S. no.	Date	Description
R1	16-12-09	Layout plan revised as per MPD 2021 as per page 7/N file no. F16(Q)190HUPW/SA(R&N)/DDA

PROJECT TITLE:
**COMMUNITY CENTER,
SECTOR 15, ROHINI**

SHEET TITLE:
LAYOUT PLAN (REVISED)

SCALE DATE SCH. NO. DRG. NO.
R-129 L-02R1

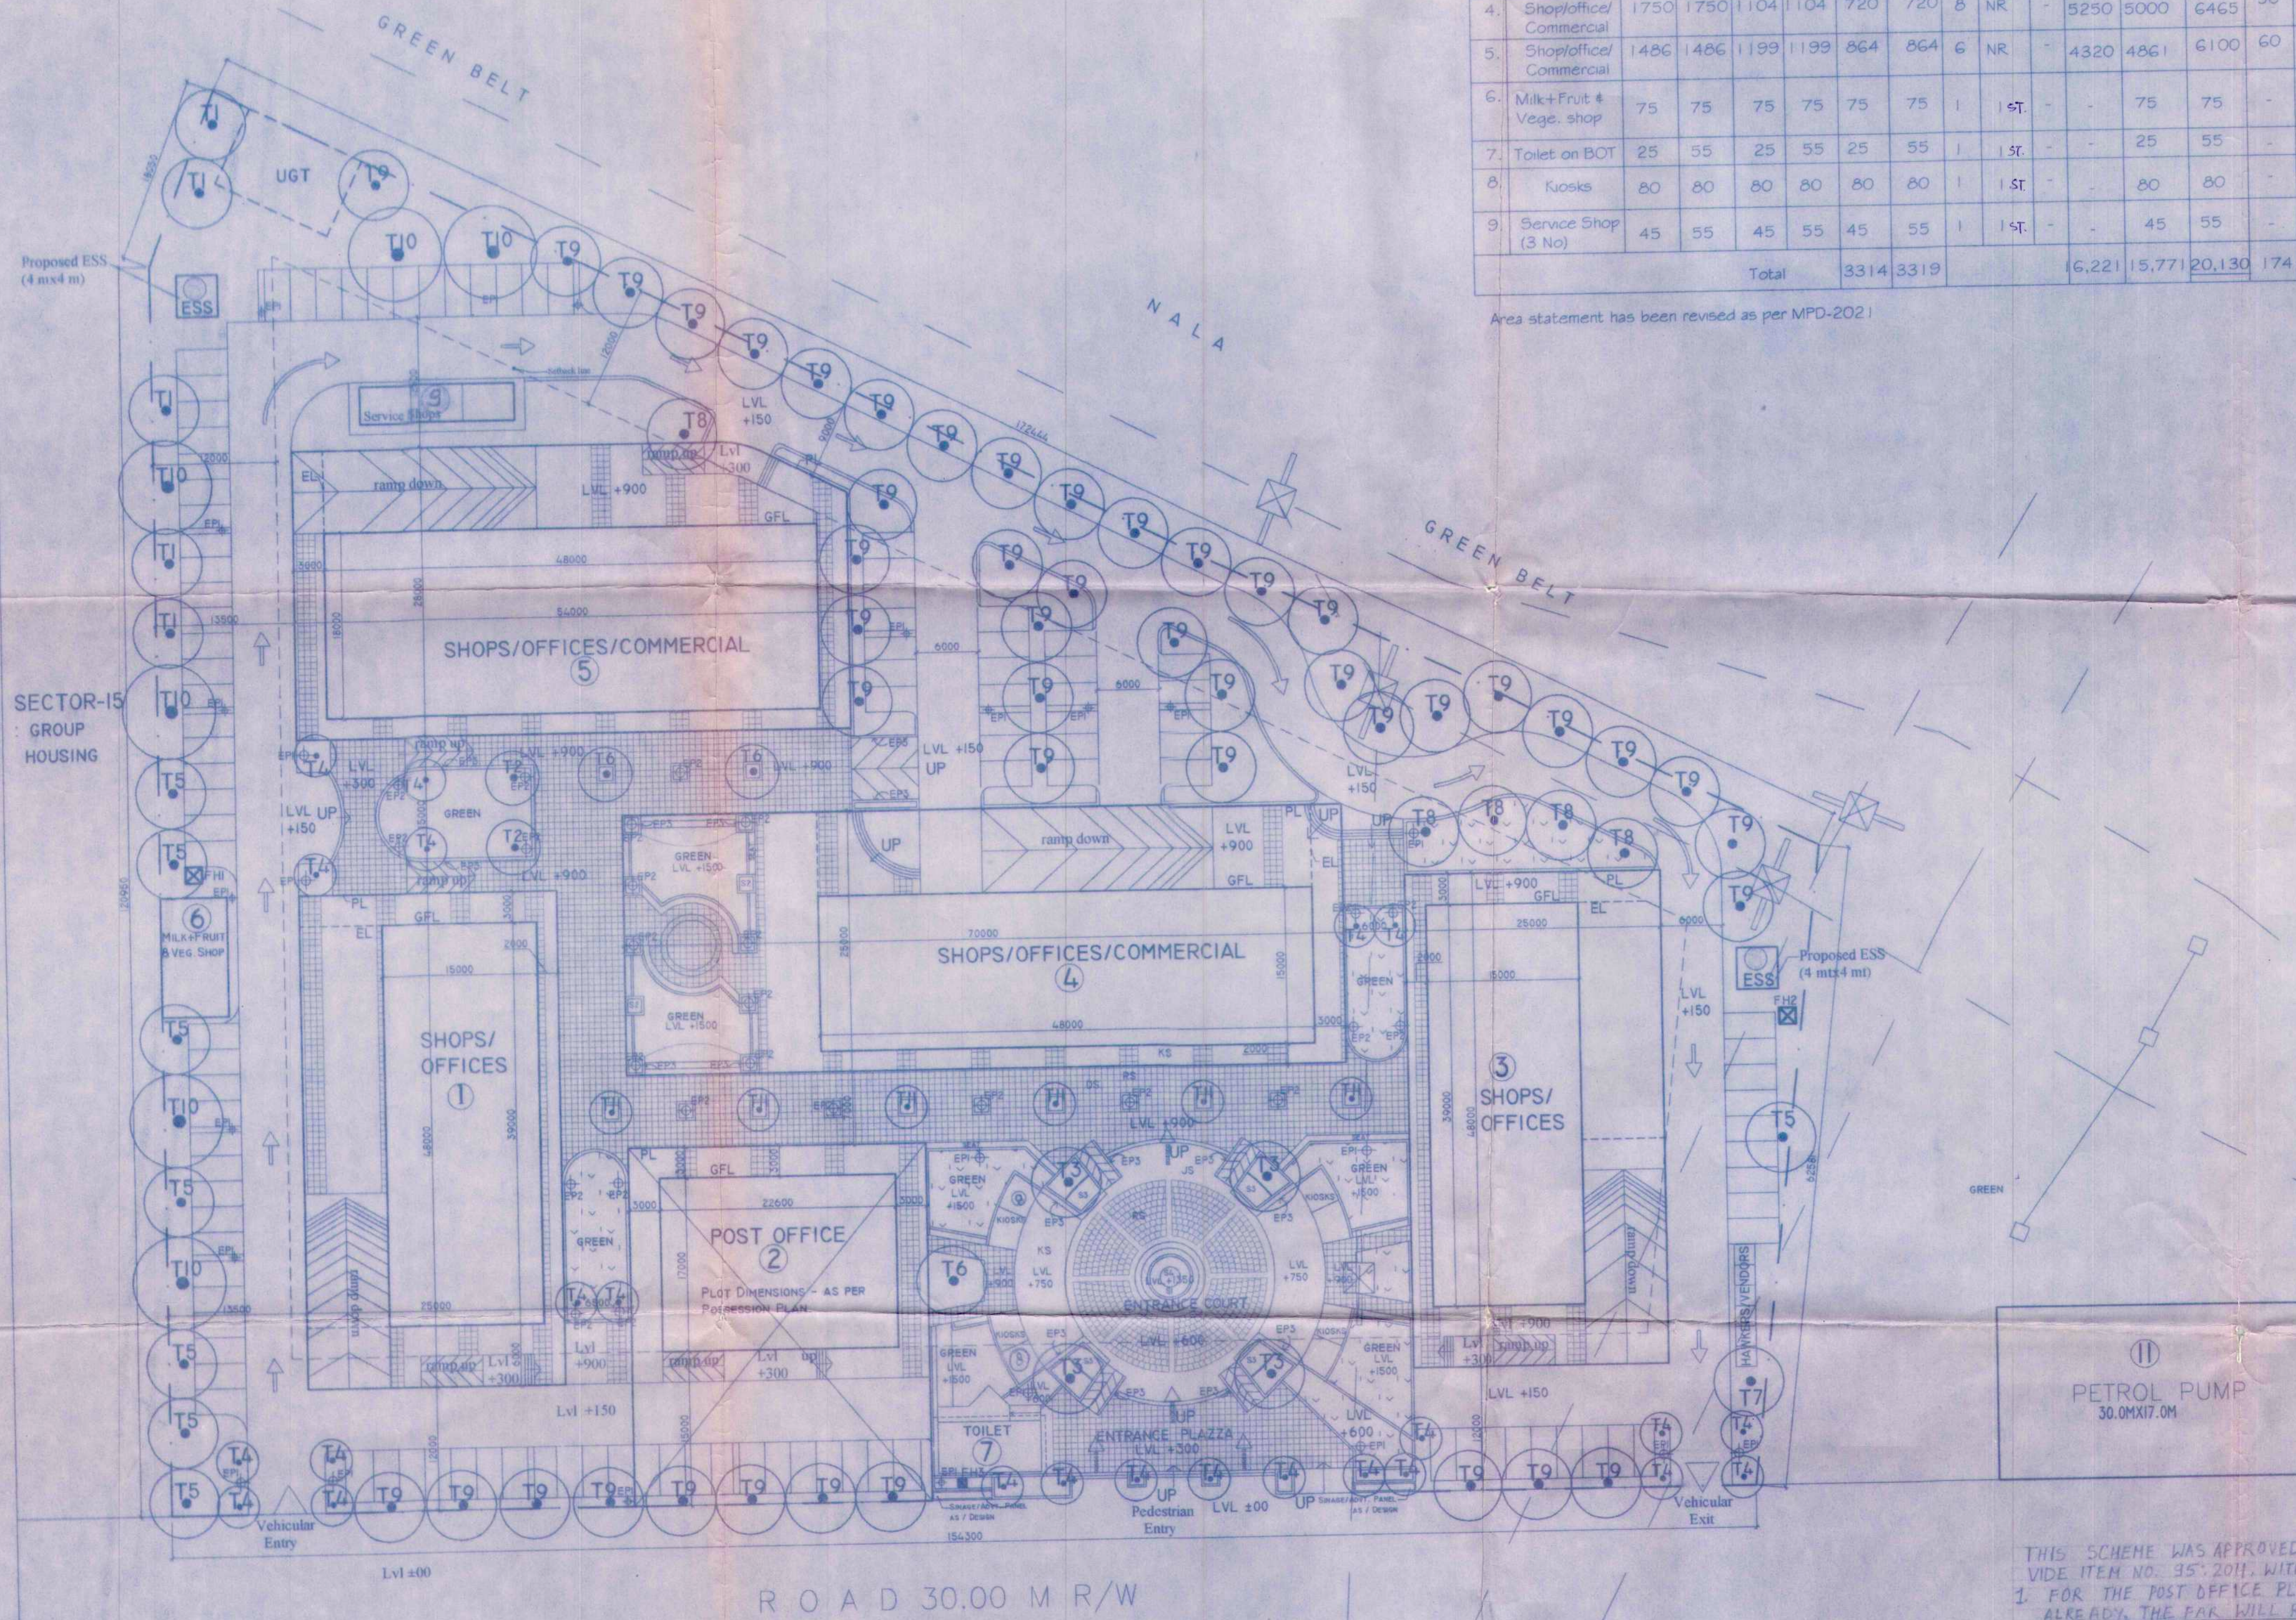
Area statement has been revised as per MPD-2021

THIS SCHEME WAS APPROVED IN THE 301ST S.C. MEETING HELD ON 19.10.2011
VIDE ITEM NO. 95.20.11, WITH OBSERVATION THAT:
1. FOR THE POST OFFICE PLOT, WHERE THE POSSESSION HAS BEEN ISSUED
ALREADY, THE FAR WILL REMAIN THE SAME, OTHER DEVELOPMENT CONTROL
NORMS FOR THE POST OFFICE WILL BE AS PER MPD-2021
2. USE & AREA OF THE BASEMENT WILL BE GOVERNED BY THE MPD-2021
ACCORDINGLY
MAXIMUM BUILT-UP AREA FOR PLOT NO. ① & PLOT NO. ② HAVE BEEN
ADJUSTED.

- The Electric Sub-station has been revised & incorporated as per letter no. EE/ED-4W(74)/DDA/08/1383 dated 29/09/08 from Ex. Engineer/ED-4/DDA
- The Capacity of Fire Water storage tank/UGR and Fire Hydrant has been incorporated in the Layout Plan as per letter no. ED-4W(74)/2007/1190 dated 22/09/09 from Ex. Engineer/ED-4/DDA
- All drawings of this project are to be read in conjunction with all services drawings, structural drawings and other details prepared by engineering wing. All necessary approvals i.e. EIA, Fire, Services, AAI approval etc. applicable if any may please be taken by engineering wing and feasibility to be carried out and confirmed before preparation of detailed working drawings, NIT and execution at site.
- Toilet on BOT basis to be provided as/standard design type A approved vide file no. F3(36)/09/HUPW/SA(WZ #D)/DDA in 296th Screening Committee item no. 40:2011
